**Revised Site Conceptual Model and Work Plan**

6211 San Pablo Avenue  
Oakland, California  
AEI Project # 280346  
Fuel Leak Case RO0000127

**FIGURE 1**  
 PROJECT NO. 280346

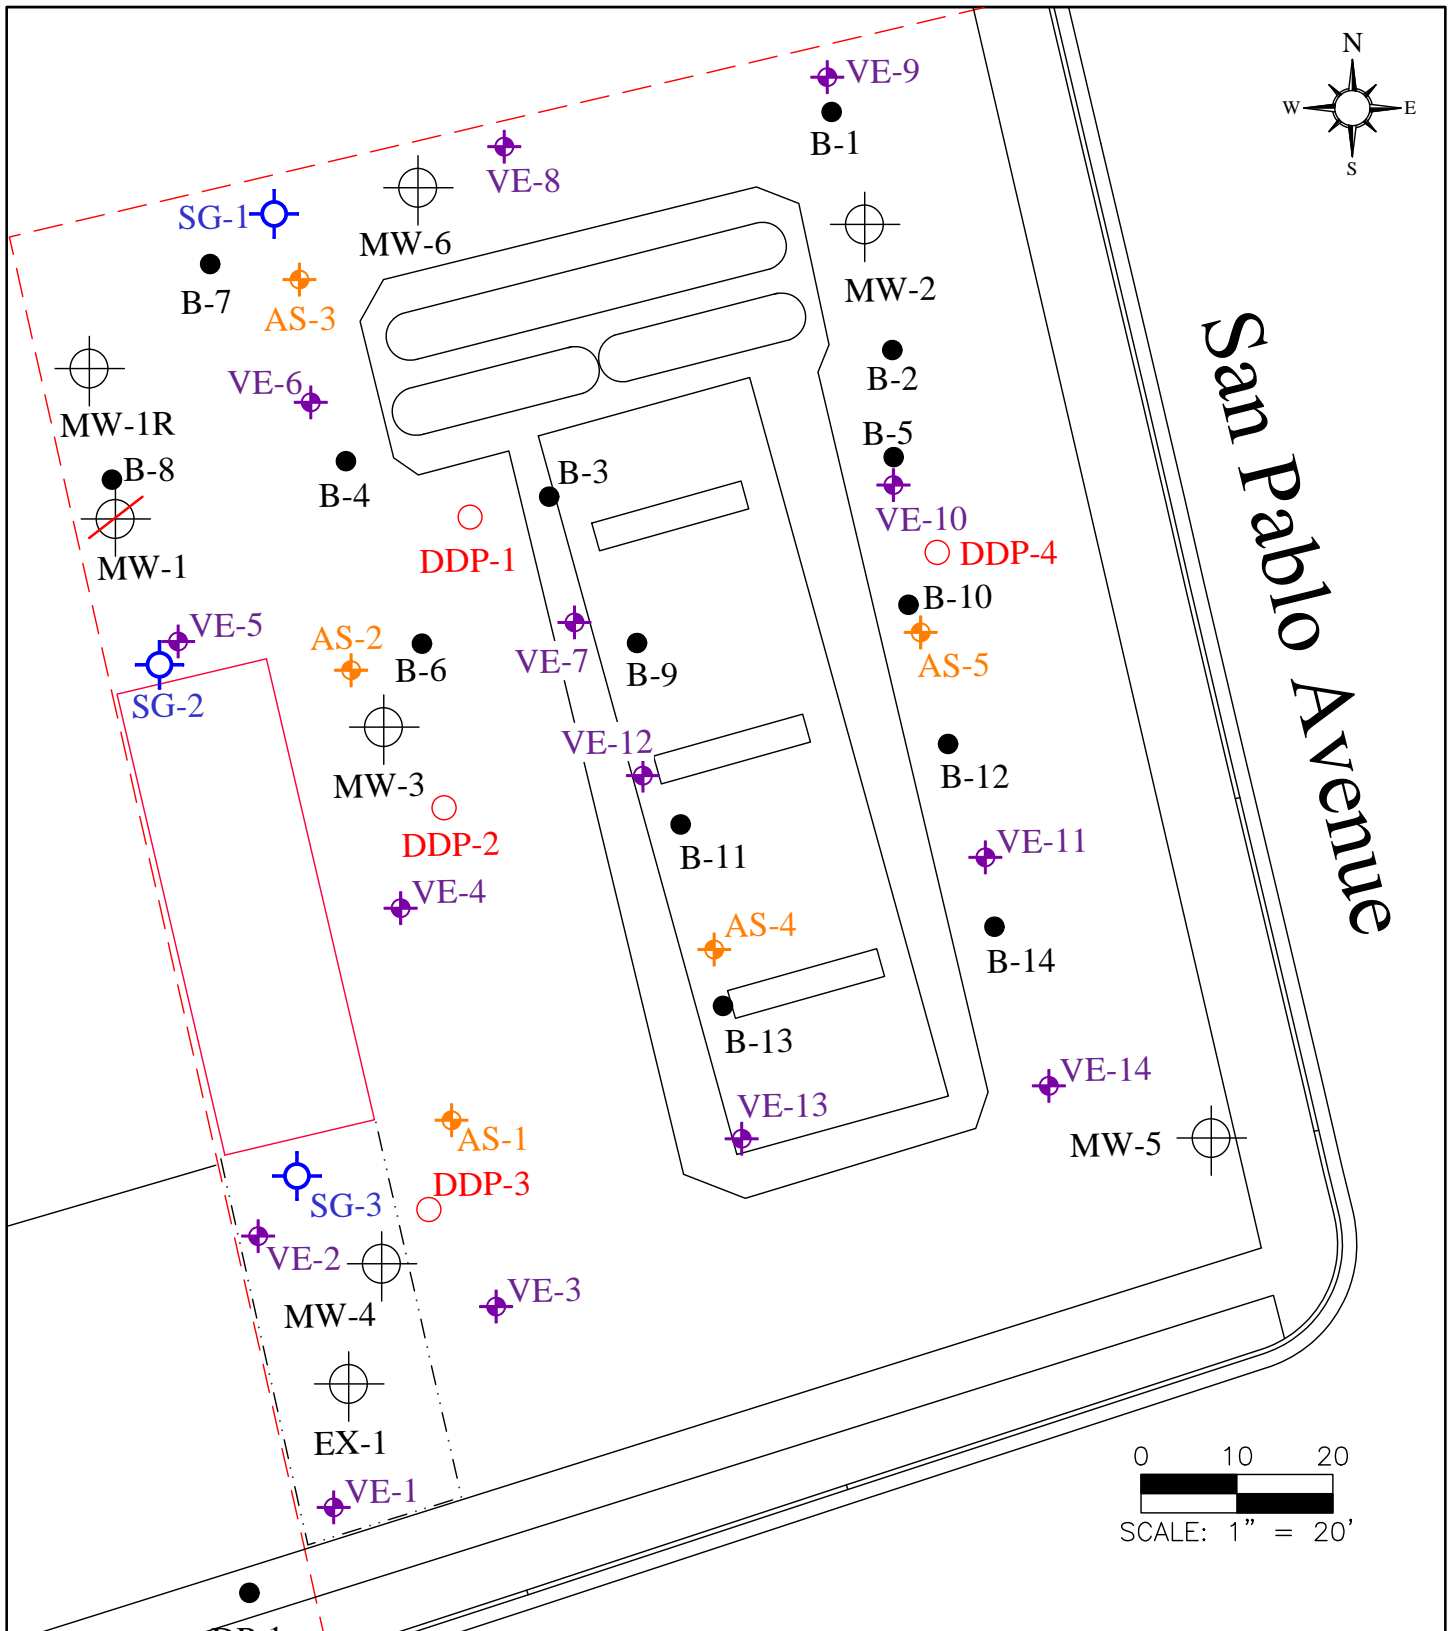
**2) Please include a thorough discussion on whether preferential migration is occurring (both groundwater and potential soil vapor) at the site, include figures that illustrate proposed boring locations as well as utilities found at the site.**

Groundwater levels at the site are on average around 6 to 7 feet bgs, which given the identified depths of the utilities in the vicinity of the site (<6.5 feet bgs), it is not expected that utility corridors would act as preferential pathways. However, during times of elevated water tables (typically rainy season), groundwater levels have been measured as high as 3.51 feet (EX-1) and 4.28 (MW-4). Therefore, it is possible that during times of elevated water tables, the deeper utilities, particular natural gas (identified at 3.5 to 4.5 feet bgs) and sewer (identified at 5.5 to 6.5 feet bgs) could act as preferential pathways for contaminate migration. Based on the possibility of the sewer and natural gas lines acting as preferential pathways, AEI has adjusted the locations for some of the proposed borings to adequately address this concern as follows (Figure 1):

- Boring DP-4 has been moved south in order to asses sewer conditions in 62<sup>nd</sup> Street. In addition, the boring has been moved in order to avoid allowing continuing access request with the property owner (Housing Authority of Oakland) to delay the investigation (the correspondence log was included in the previous Herschy workplan dated May 27, 2008 as Appendix G).
- Borings SB-5 will be moved to the northwest to investigate conditions along the natural gas line in the southern portion of 62<sup>nd</sup> Street.
- Boring SB-8 has been moved to the northwest to investigate conditions along the sewer line in 62<sup>nd</sup> Street.
- Boring SB-9 has been moved towards the west to investigate conditions along the sewer line located in Marshall Street.
- Boring SB-14 has been moved to the south to investigation conditions along the sewer line in 62<sup>nd</sup> Street.

The adjusted locations of these borings will allow for both further delineation of the contaminate plume and investigation of the utility corridors. The location of the proposed borings are based off of estimated utility maps generated by the previous consultant. Prior to completion of the borings, the location of the utilities will be verified and boring locations adjusted as necessary based on utility location, feasibility based on traffic patterns, and worker safety.
